# HI-STAR 180 STRUCTURAL OPEN TECHNICAL ISSUES

(USNRC Docket No. 71-9325)  
*A Presentation to the SFST*

by  
Chuck Bullard  
Principal Engineer  
Holtec International  
June 27, 2008

FIGURE 2A.4.3 - 1/8th Scale Initial Impact Limiter Configuration - Comparison of Static Force-Crush Data from Test and Simulation - END DROP

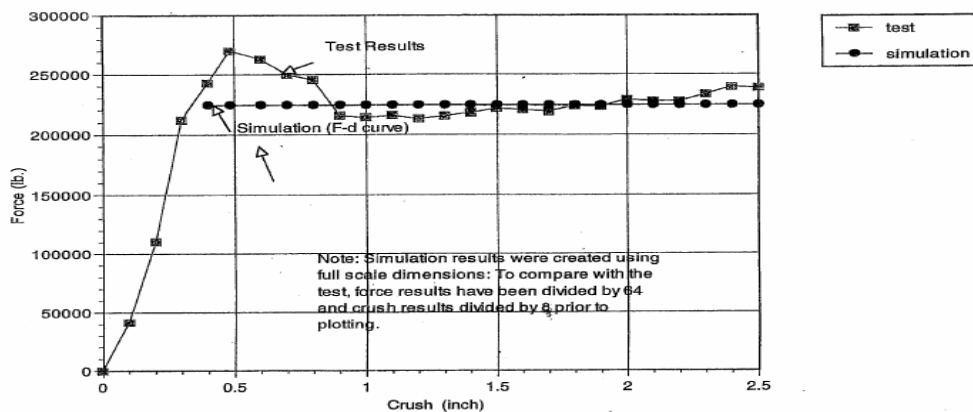
- **OTI**
  - DOES PRECRUSH ALTER PROPERTIES?
- **PATH FORWARD**
  - PRECRUSHING IS PERFORMED ONLY FOR A THIN LAYER NEAR TARGET CONTACT SURFACE AND IS PART OF MANUFACTURER'S PRODUCTION PROCESS.
  - NO CHANGE TO GLOBAL RESPONSE OF IMPACT LIMITER. DEMONSTRATED BY 1/8 SCALE TESTS DURING HI-STAR 100 TEST SERIES.
  - ONCE SPIKE IS OVERCOME, RESPONSE IS LIKE ELASTIC-PERFECTLY PLASTIC MATERIAL UNTIL LOCK-UP. THIS IS THE MATERIAL BEHAVIOR THAT HAS BEEN MODELED IN LS-DYNA. THE FOLLOWING FIGURES ARE REPRODUCED FROM THE HI-STAR 100 SAR.

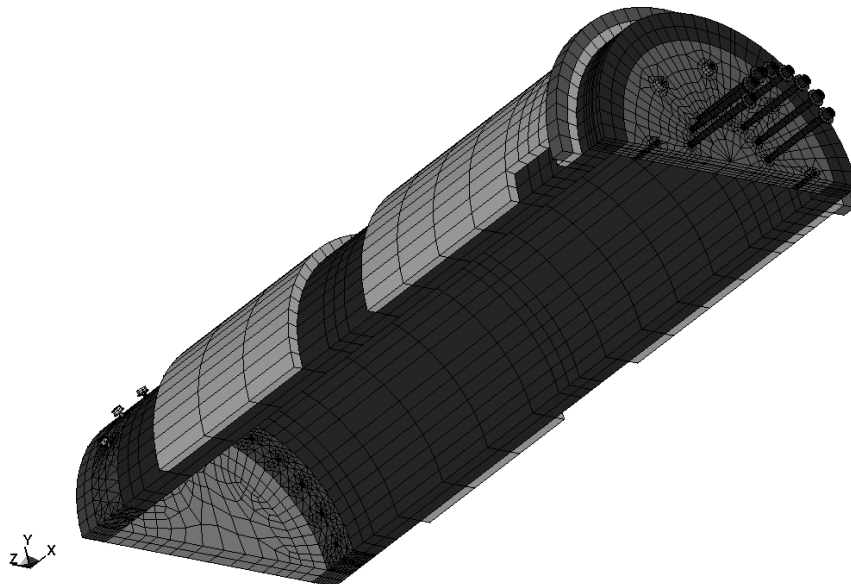
- **OTI**
  - PROVIDE ADDITIONAL EXPLANATION OF IMPACT LIMITER CONNECTION TO OVERPACK
- **RESPONSE**
  - CONTACT\_TIED\_SURFACE\_TO\_SURFACE COMMAND IS USED TO JOIN TWO SEPARATE MESHED REGIONS OF THE OVERPACK. SEE FIGURE BELOW.

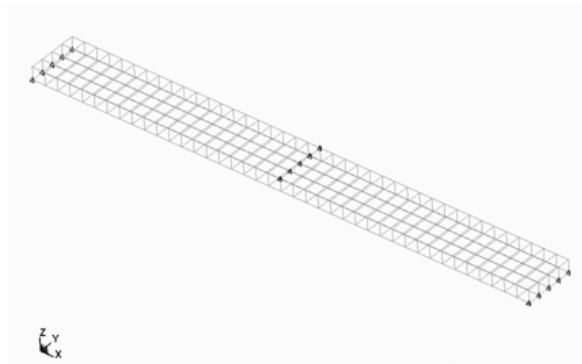
- **OTI**
  - JUSTIFY USE OF SINGLE LAYER THICK SHELLS WITH TWO INTEGRATION POINTS
- **PATH FORWARD**
  - CHARACTERISTIC WIDTH TO PANEL THICKNESS IS  $206\text{mm}/15\text{mm} = 13.73$ , WHICH QUALIFIES THE PANEL AS A THIN PLATE (PER ASME CODE).
  - A COMPARISON WITH A CLASSICAL CLOSED FORM PLATE SOLUTION WILL BE USED TO DEMONSTRATE CONVERGENCE FOR BOTH MESH SIZE AND INTEGRATION POINTS USING THE LS-DYNA THICK SHELL ELEMENT. THIS IS DESIGNATED AS “**MODEL 4**”.
